## Request for Class II Permissive Change(C2PC)

FCC ID: VG8XM0P04YY

Please be notified that we, the undersigned, **Guangdong Midea Kitchen Appliances Manufacturing Co., Ltd.** declare that the reasons for this class II permissive change are as below:

This is a C2PC application for which the previous grant was issued on 11/06/2022.

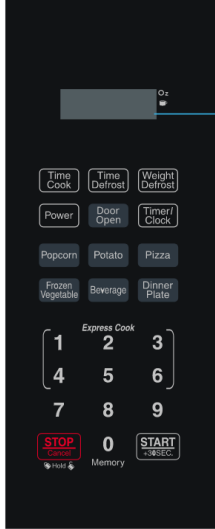
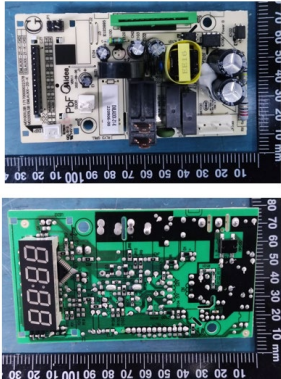
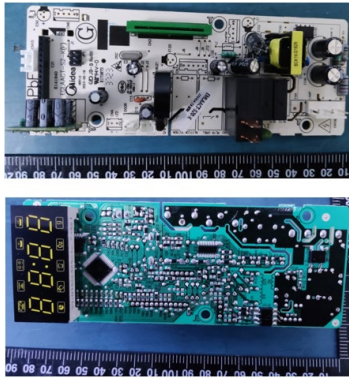
No.:	Original	New	Difference(s)
1			<p>Keypad: Updated front keypad to accommodate child lock function (Child resistant oven door function)</p>
2			<p>Mother board: Modified the peripheral circuit (non-RF circuit) and some individual components and PCB layout. The magnetron and other circuit are exactly same as before</p>

3	Not Applicable		The new one adds a solenoid valve locking mechanism, the original is not.
---	----------------	---	---
